Our Ref: P14/14

27th July 2015

Goldring Close, Hayling Island – Ecological Comments with Respect to the Lighting Strategy (Updated 27th July 2015)

Drawing Title
On Site Street lighting Layout

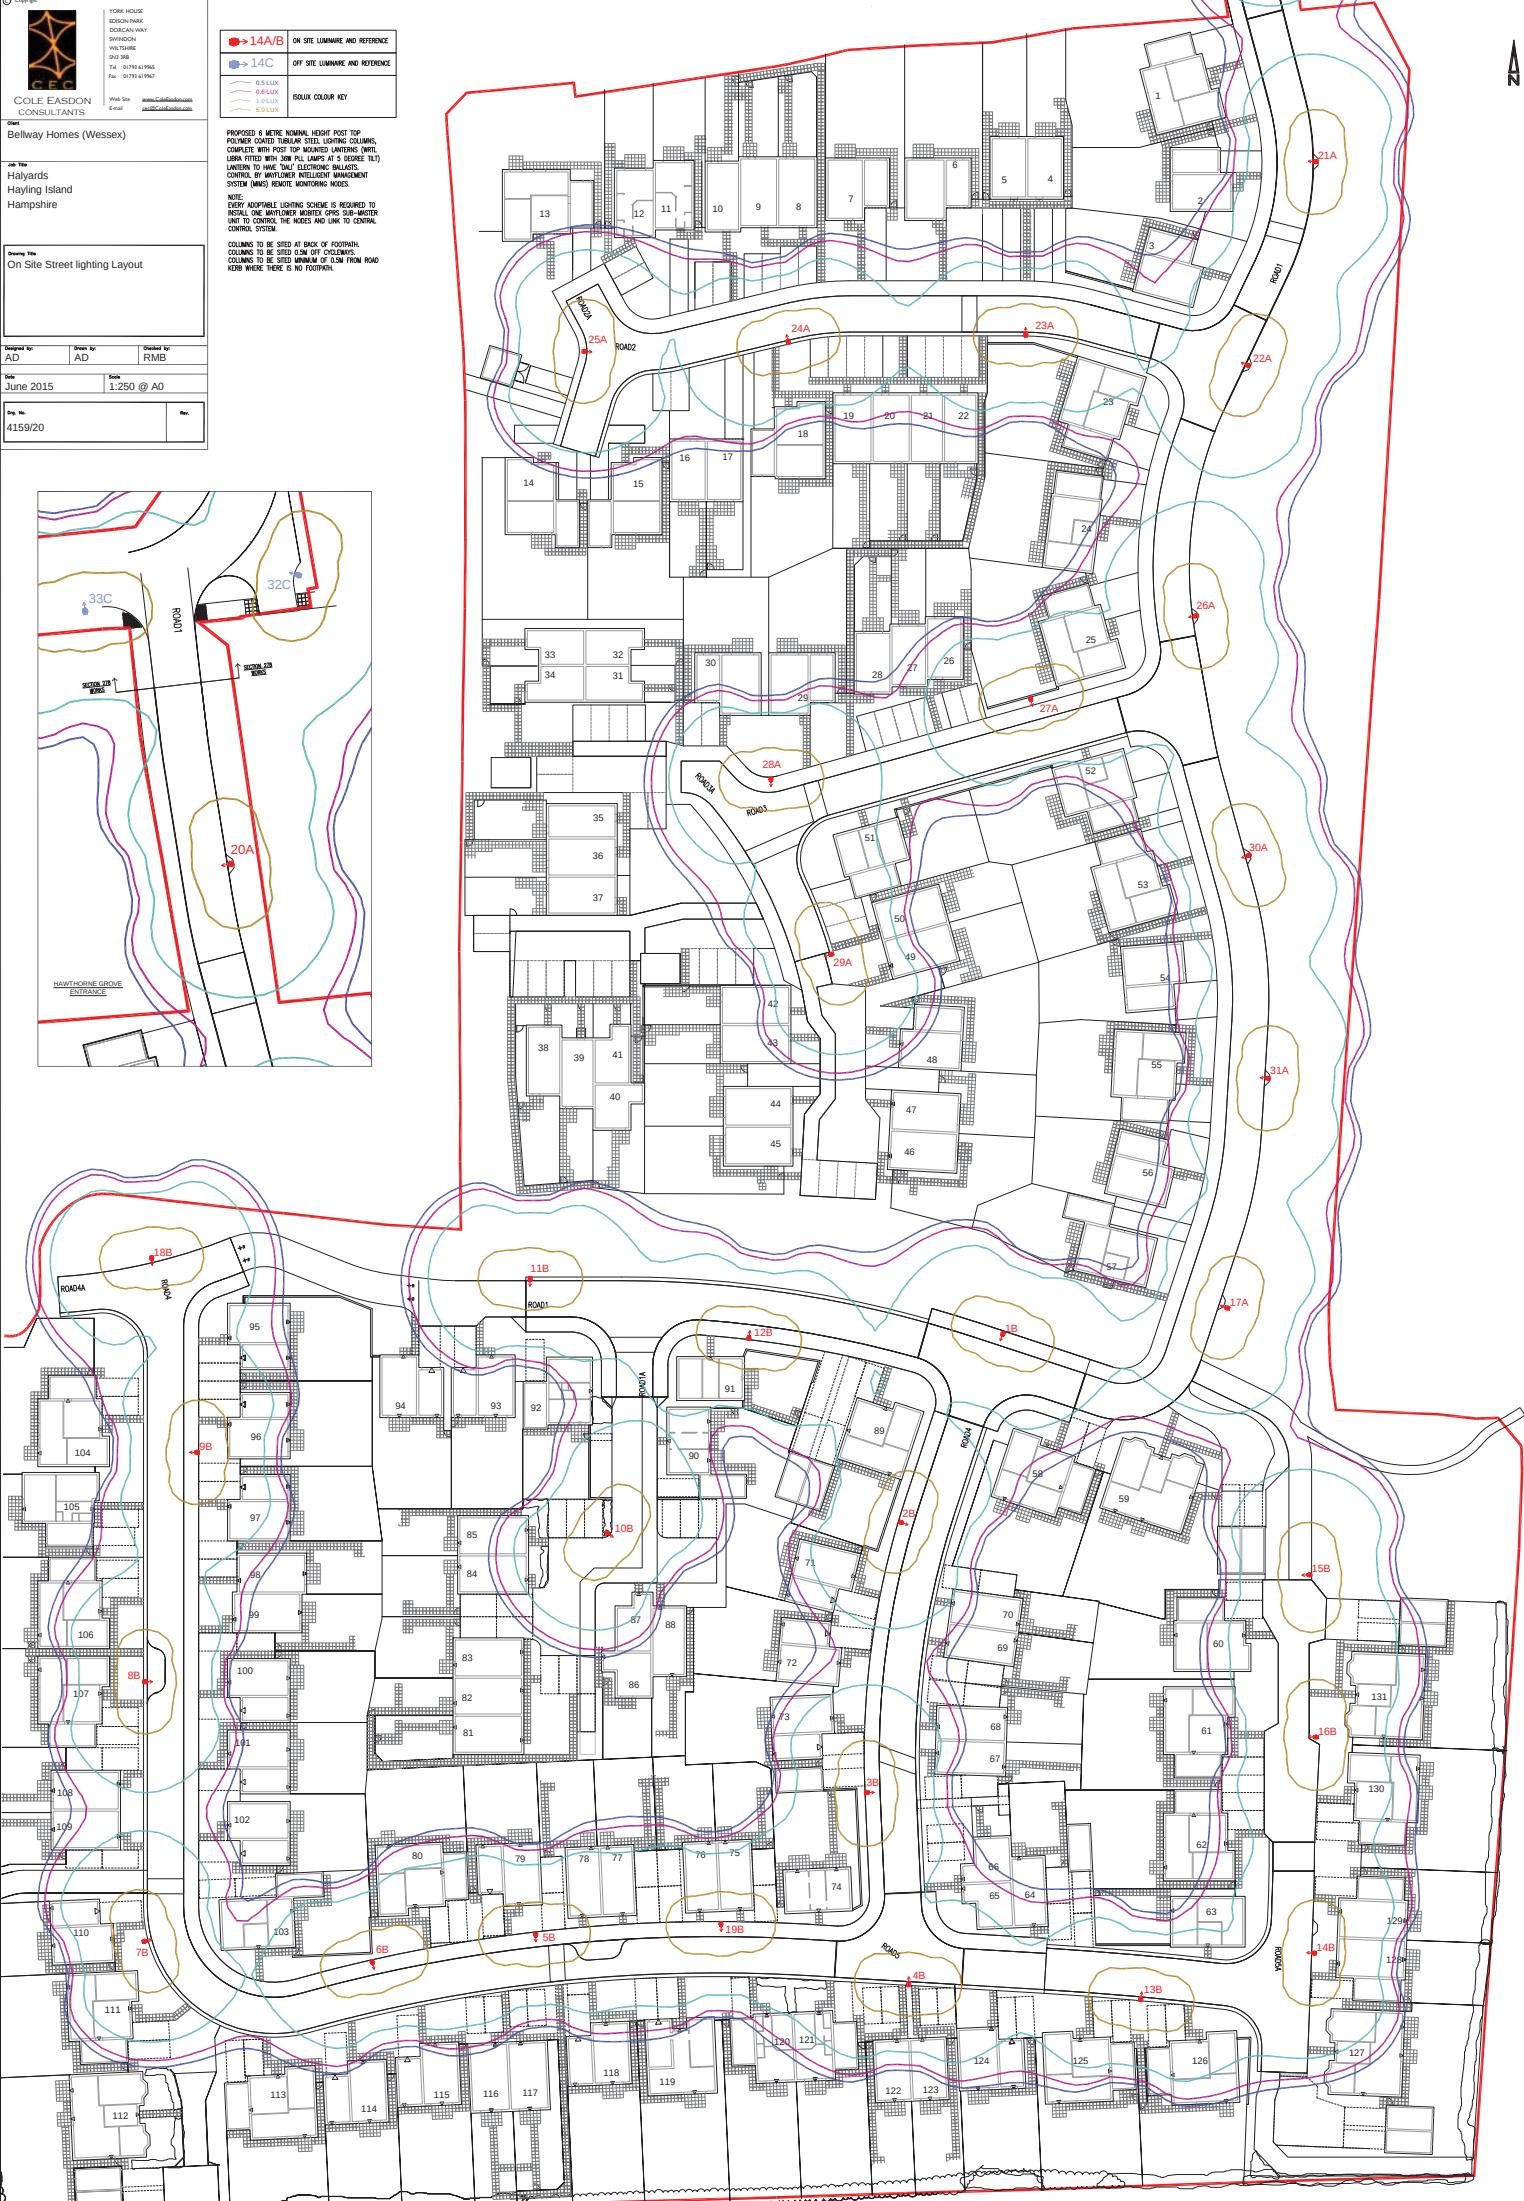
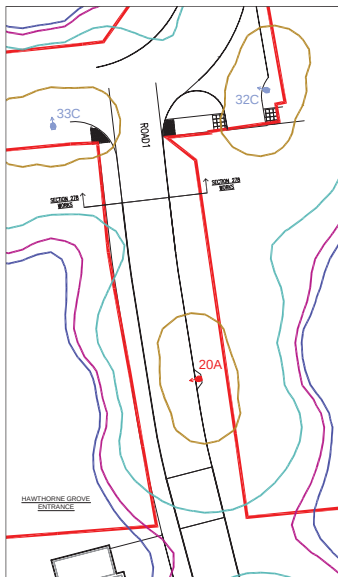
Although I do not consider that there is an issue with regards to Brent Geese I do believe the lighting along the central hedgerow is not compliant with the recommendations outlined in the 'Biodiversity, Mitigation & Enhancement Plan', which stipulates that sensitive lighting will be used to avoid illuminating important features such as mature trees and hedgerows. The current strategy sets to illuminate the entire central hedgerow, including two mature Oak trees in the western end. I would suggest that this line be modified to ensure the hedgerow is not subjected to high levels of light pollution and consequently the features remains useable by bats and invertebrates.

The street lighting locations are along the access roads, set back from the eastern boundary and as such the illumination contours do not project beyond the mature hedgerow. With light spill not extending beyond the site boundary and into the adjacent field to the east, combined with the fact that Brent Geese are only present in the UK between October and March and when present are highly unlikely to be in the field overnight when the lighting will be utilised, I do not consider that the Brent Geese will be negatively impacted upon as a result of the lighting strategy associated with this scheme. However, I would suggest that you impose restrictions for residents installing additional external lighting (particularly for the houses along the eastern boundary) to avoid any potential light spill issues in the future.

I would also recommend that the lighting along the central hedgerow be modified to ensure that bats and invertebrates are not adversely affected in the long-term.

Following consultation with yourself on Monday 27th July 2015 regarding the central hedgerow I consider that the revised lighting approach of replacing street lighting columns 1B, 11B and 18B with low level bollard lighting will alleviate the potential issue of light spill on the hedgerow and mature trees.
